## Addendum No. 1

City of Coquitlam

**Tender No. 87424**  
**North Road Watermain (Como Lake Ave – Chapman Ave)**  
 (Consists of 30 PAGES)

Issue Date: October 20, 2025

DRAWING NUMBER:
WM-2

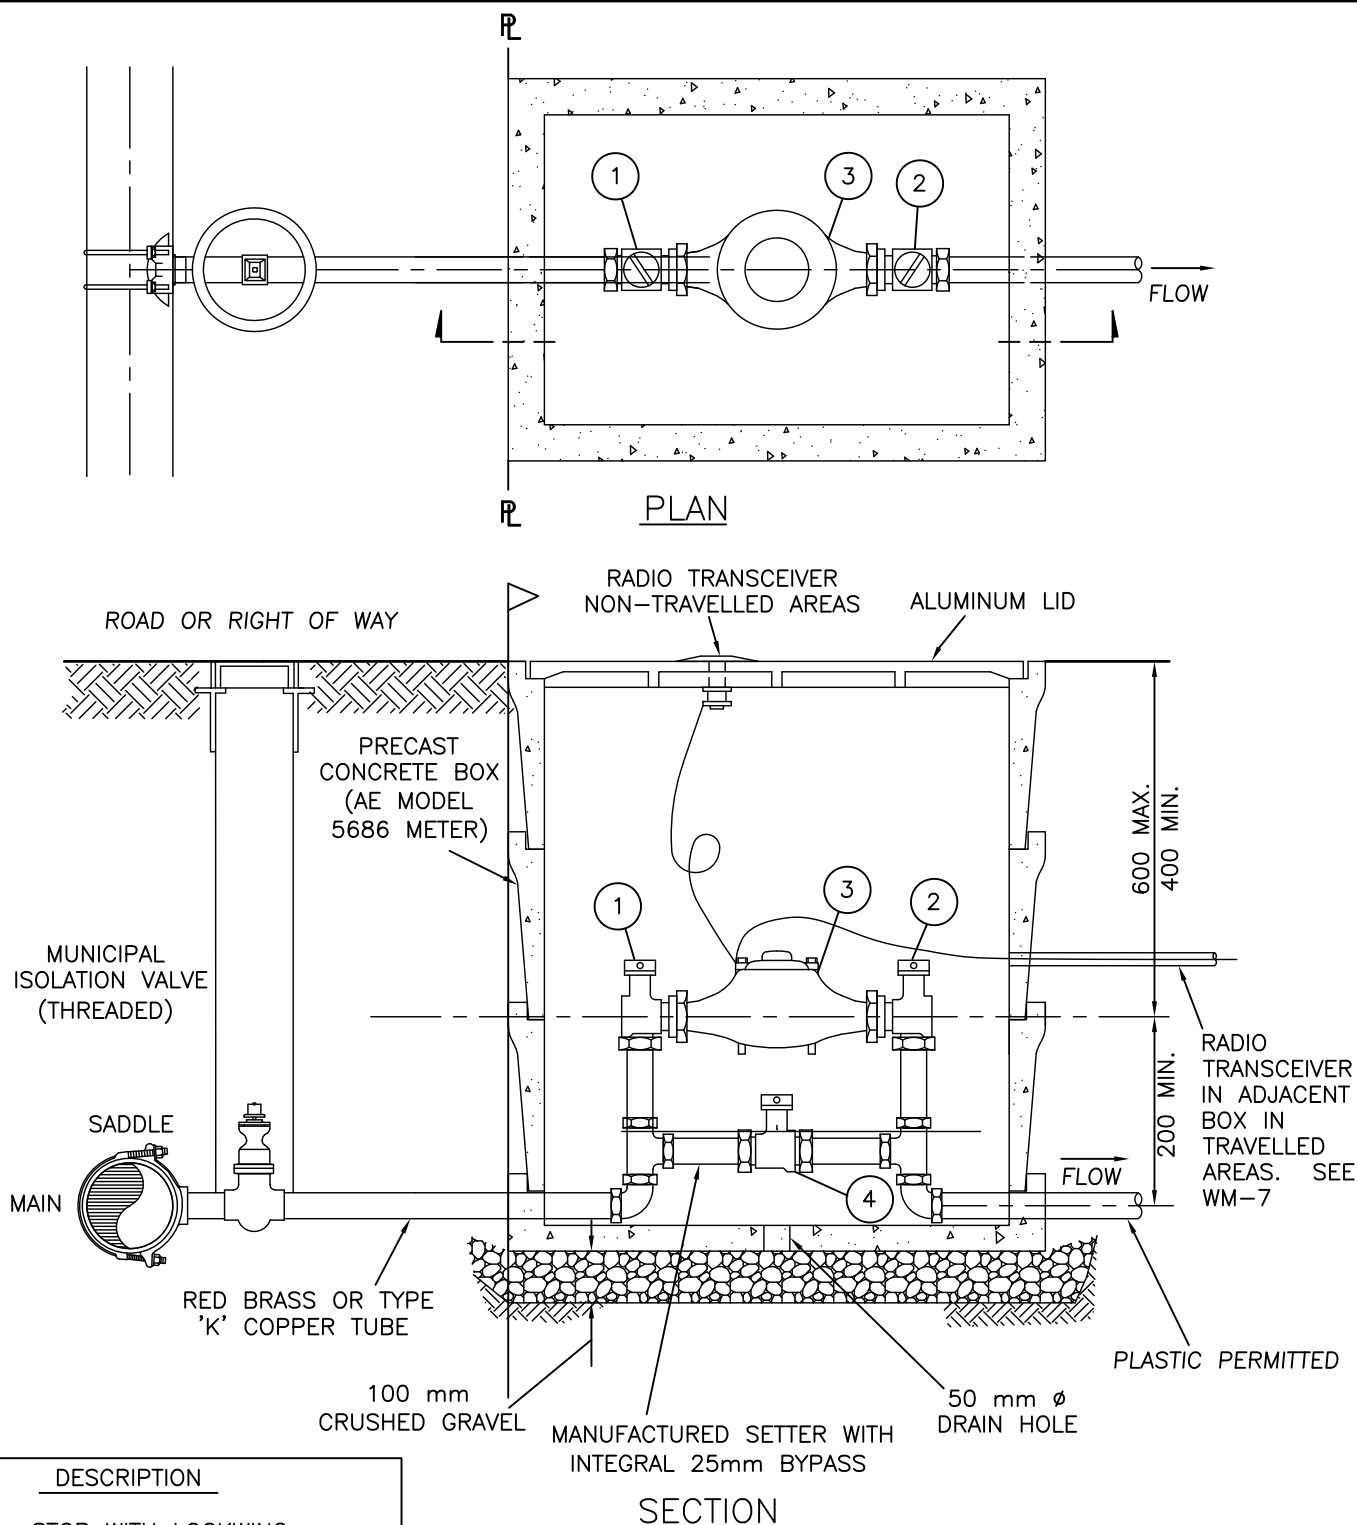
Payment for service connections includes mainline saddles, corporation stops, curb stops, copper or Municipex service pipes c/w #10 AWG tracer wire, valves and all valve boxes c/w lids marked "WATER", 150mm PVC riser, **new water meter, setter and boxes per WM-2 and WM-3**, and all related fittings and appurtenances specified and/or shown on Standard Detail Drawings **COQ-W2d, COQ-W2e**. Payment includes all applicable work described in 1.8.2 of this section.

**ADD: WM-2, WM-3**

**A18: Refer to COQ-W2d and COQ-W2e in Appendix C for water service requirements. Refer to WM-2 and WM-3 included in this addendum as well as City of Coquitlam Water Meter Specifications:**

**A23: New meter, meter setter and meter box will be required at all existing service connections as per the Contract Drawings and WM-2 and WM-3.**
